ADDENDUM
NO. 4

Loy Norrix High School Mechanical Improvements
606 East Kilgore Rd
Kalamazoo, MI 49001

ADDENDUM NO. 2

| ARCHITECT'S PROJECT NO.: | 21-807.00 |

Refer to Sheet(s): E802

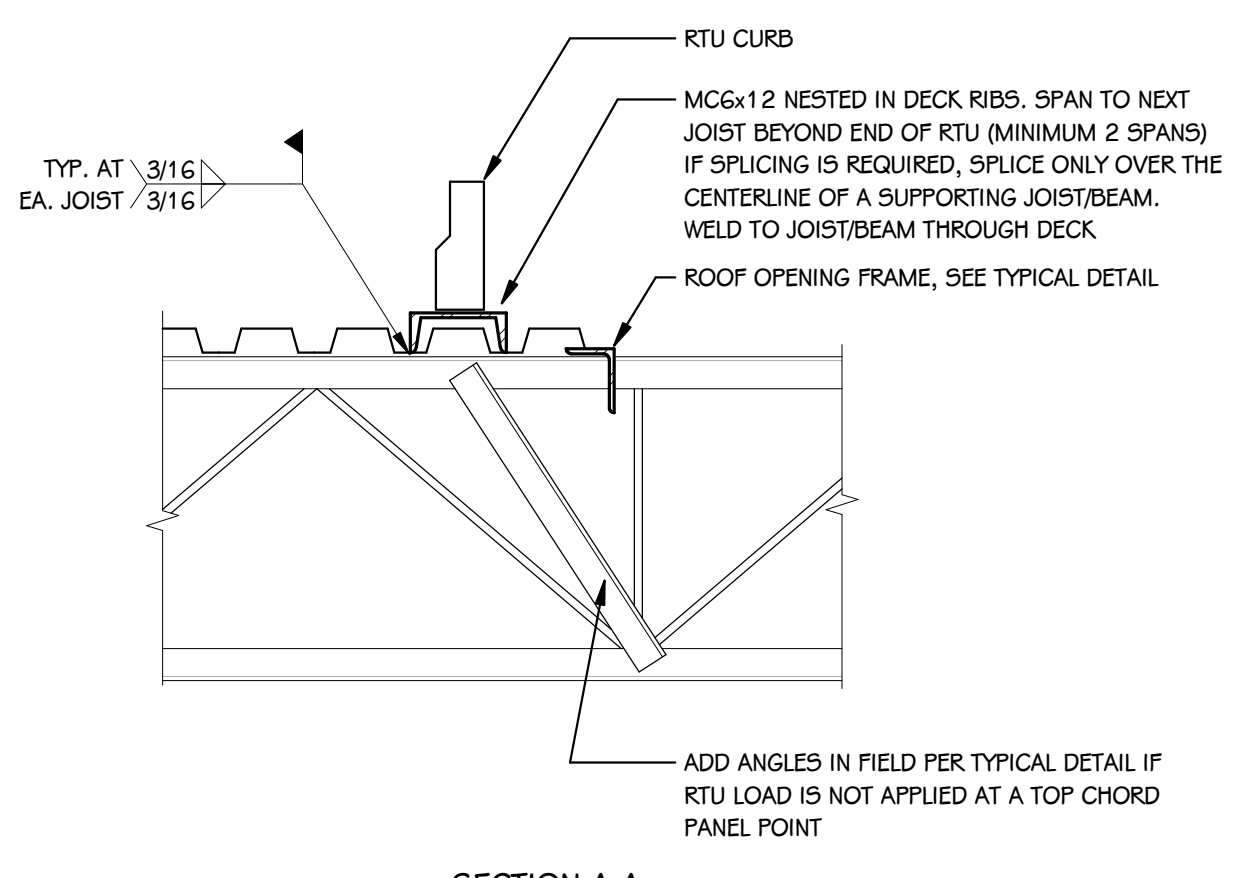
ADD-2 Item No. D-5 - Added Existing Switchgear Location

Showed existing switchgear location on drawing E802.

TYPICAL TOP SUPPORT OF MASONRY WALL
 SCALE: NONE

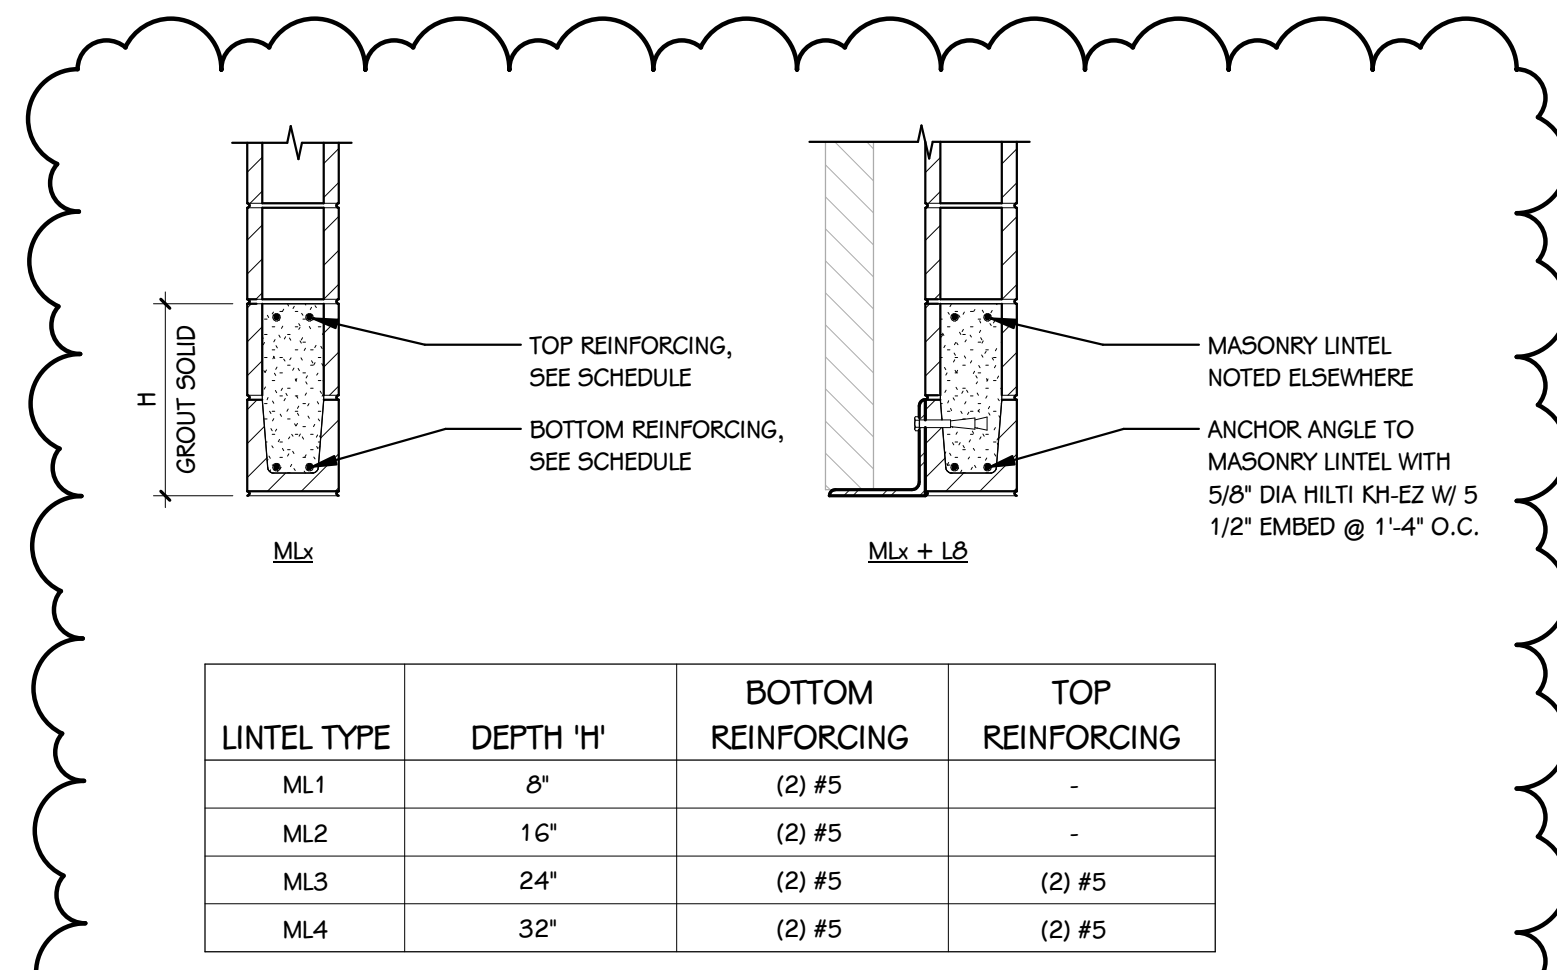
Added lintel designations on S 201K at locations of large duct penetrations. Added details for masonry lintels and top of masonry wall support on S 002.

SHEET NUMBER
S 201K
21-807.00

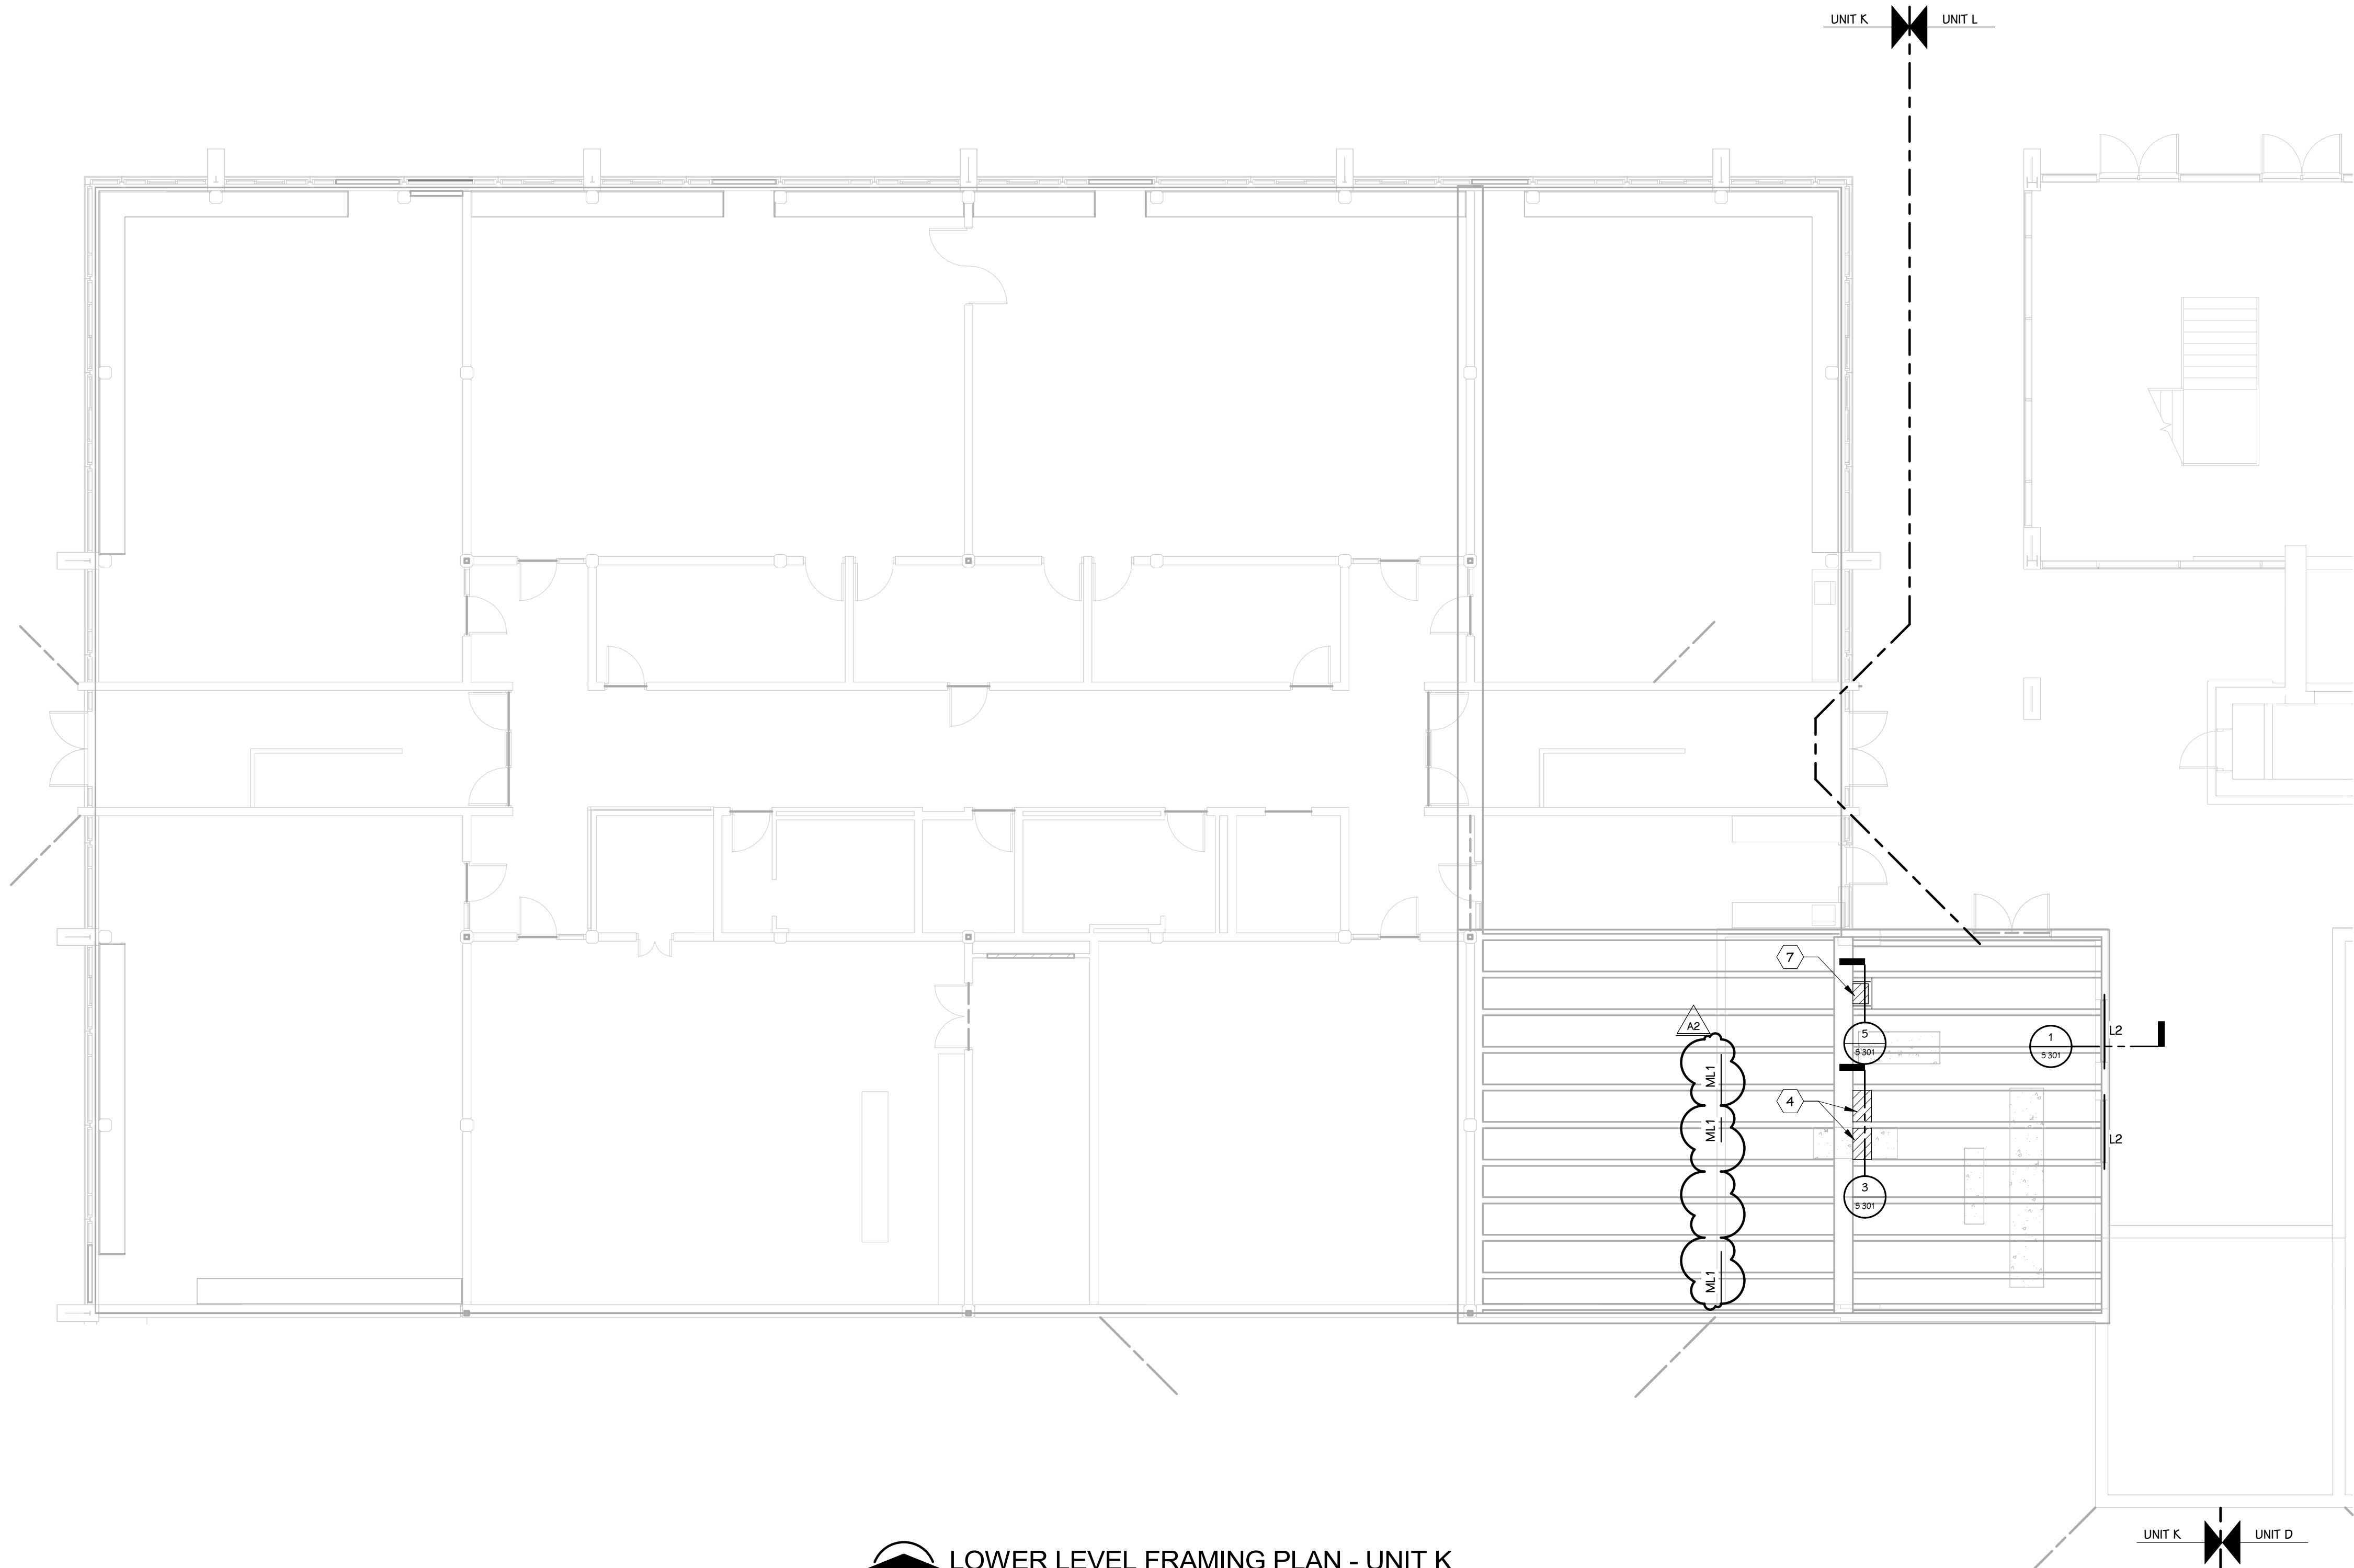
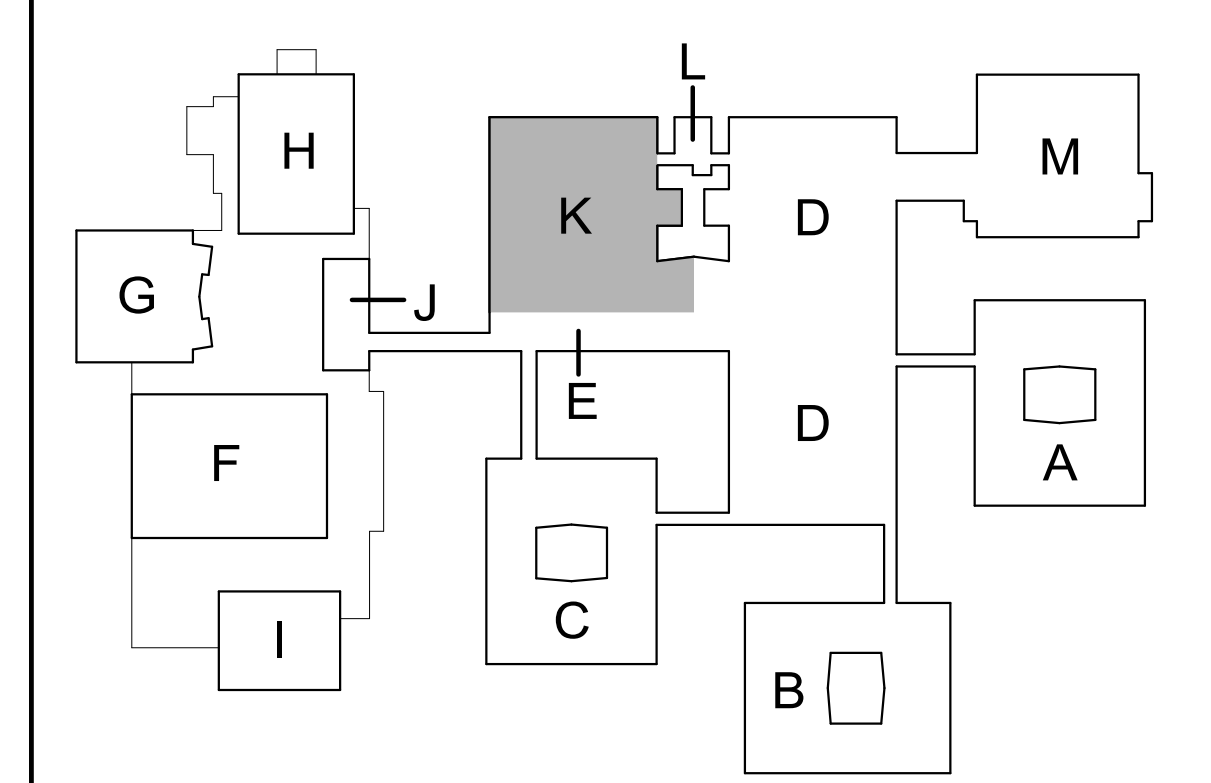
ADD-2 Item No. D-1 - Classroom K-1 Lintel and Wall Details

Refer to Sheet[s]: S 002, S 201K
